RICHMIL RANCH OPEN SPACE PARKING LOT EXPANSION ARAPAHOE COUNTY, COLORADO

SHEET NO.	INDEX OF SHEETS	
	SUBSET SHEETS	DESCRIPTION
01	TTL-01	TITLE SHEET
02	PLN-01	SITE PLANS
03	GRD-01 TO GRD -02	GRADING PLANS
05	UTL-01 TO UTL-02	UTILITY PLANS
07	STR-01	STRIPING AND CIRCULATION PLANS
08	DET-01 TO DET-04	DETAILS

MAY 2024 - FINAL PLANS - NOT FOR CONSTRUCTION

ARAPAHOE COUNTY			
RICHMIL RANCH OPEN SPACE			
UTILITY PLAN			
DESIGNER: ATC	STR. NO'S. ###		
DETAILER: DCP	NO'S. ###		
SUBSET: GENERAL	SHEETS: UTL-01 OF 02

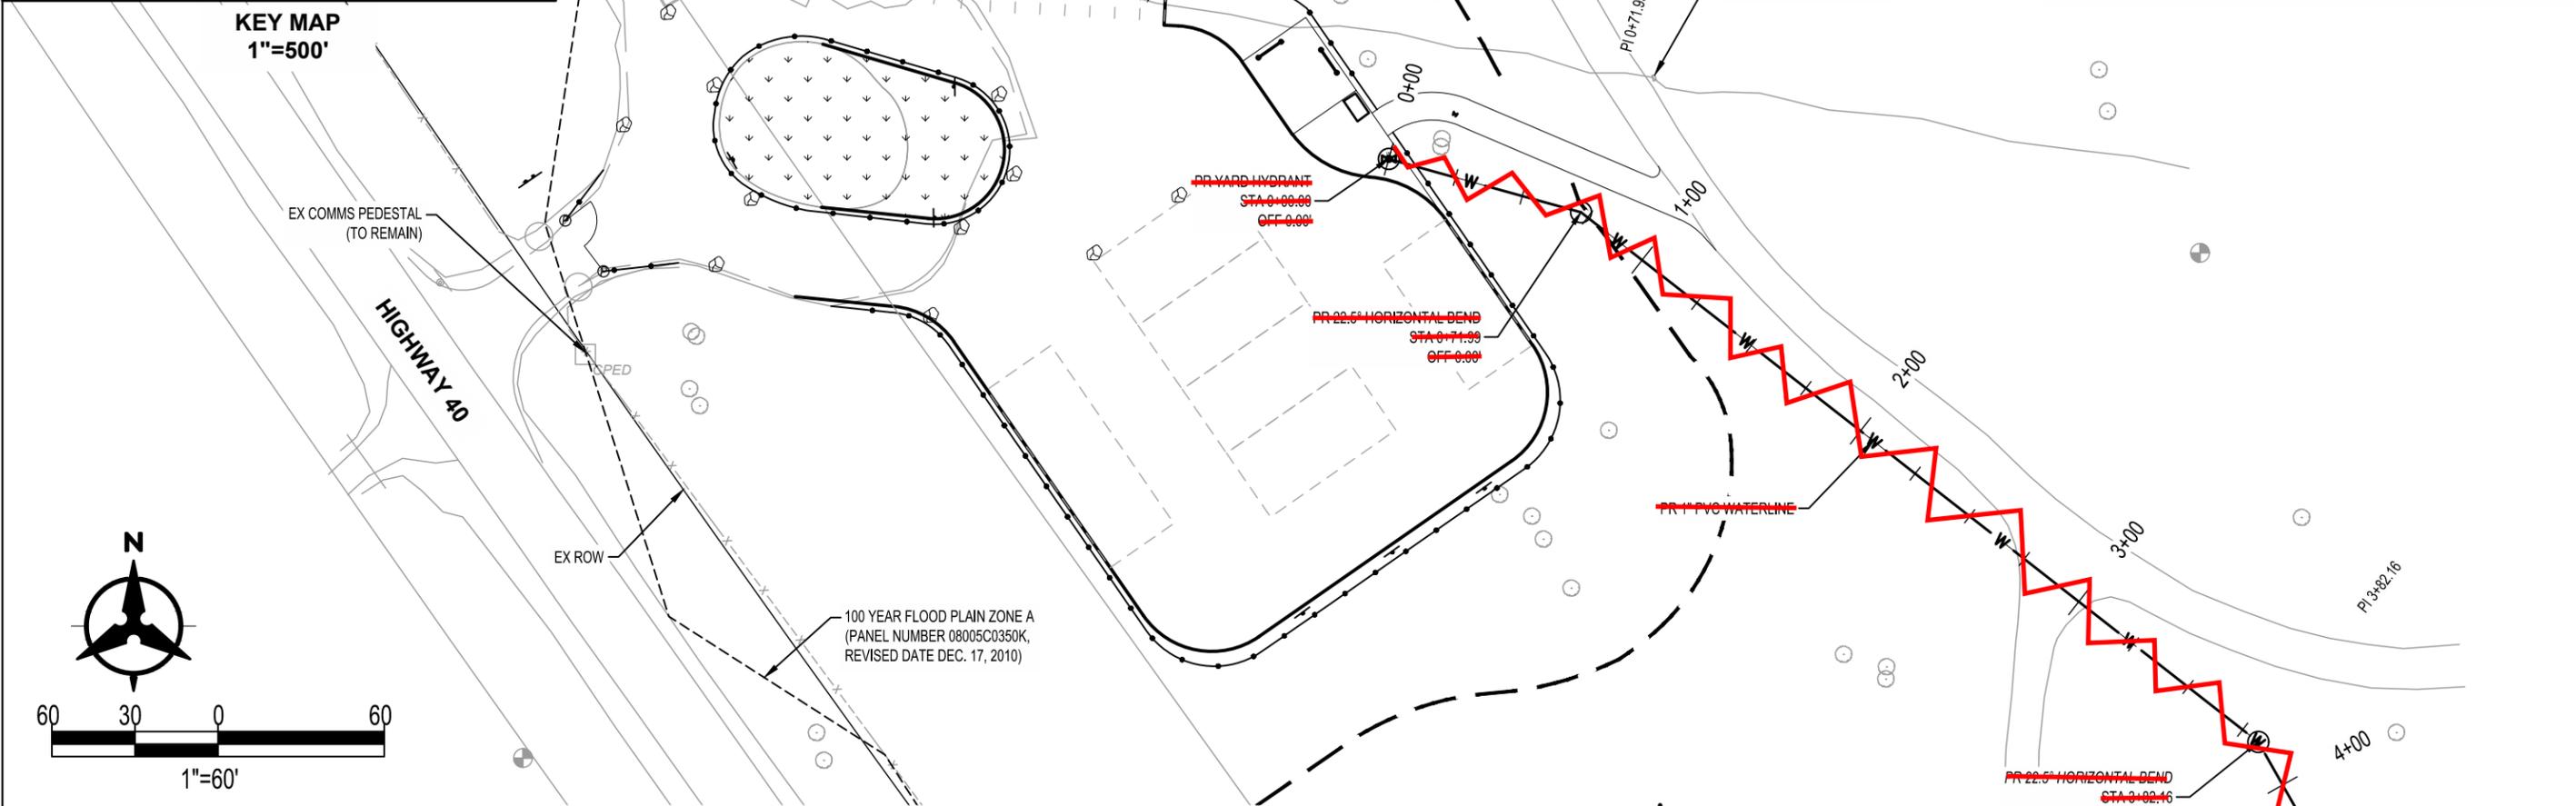
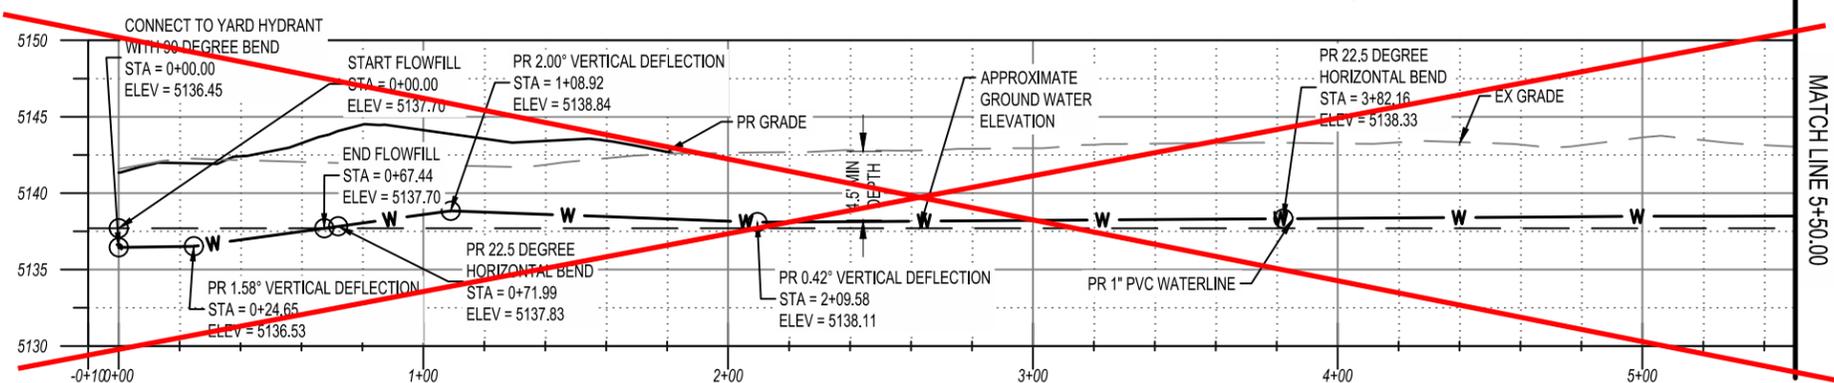
4. GROUND WATER TABLE HEIGHT HAS BEEN APPROXIMATED FROM DATA OBTAINED BY VIVID ENGINEERING GROUP'S GEOTECHNICAL AND PAVEMENT DESIGN REPORT, DATED NOVEMBER 3, 2023. ~~SHOULD THE CONTRACTOR DISCOVER GROUND WATER ABOVE THE PROPOSED 4.5' WATER LINE DEPTH, THE LINE SHALL REQUIRE INSULATION.~~

Waterline and associated work will not be performed as part of this project.
